All American & Vision A/C Not Cooling Service Update #20-0702

A/C Lines Could Contact Door Mechanism

FIGURE #1

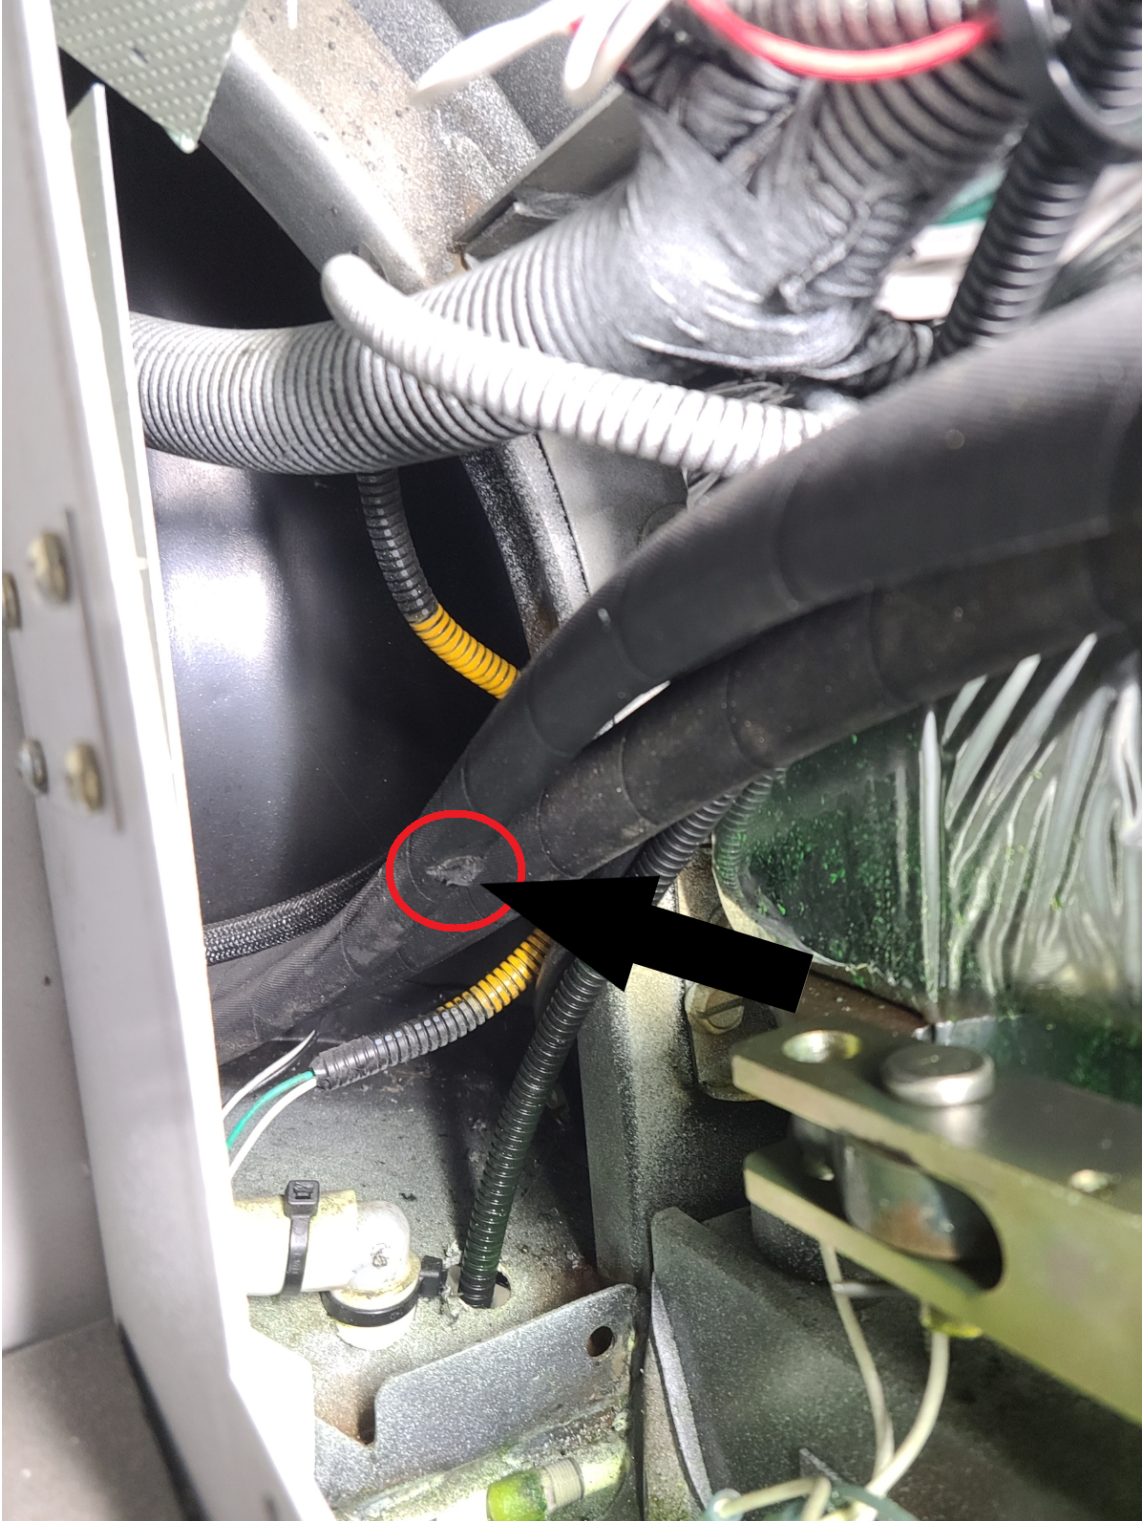
FIGURE #1 shows the open panel above the entrance door. The red circle shows the mark in the hose and the black arrow indicates the travel of the door mechanism and how it would contact the hose. You can also see the green dye on the foil insulation.
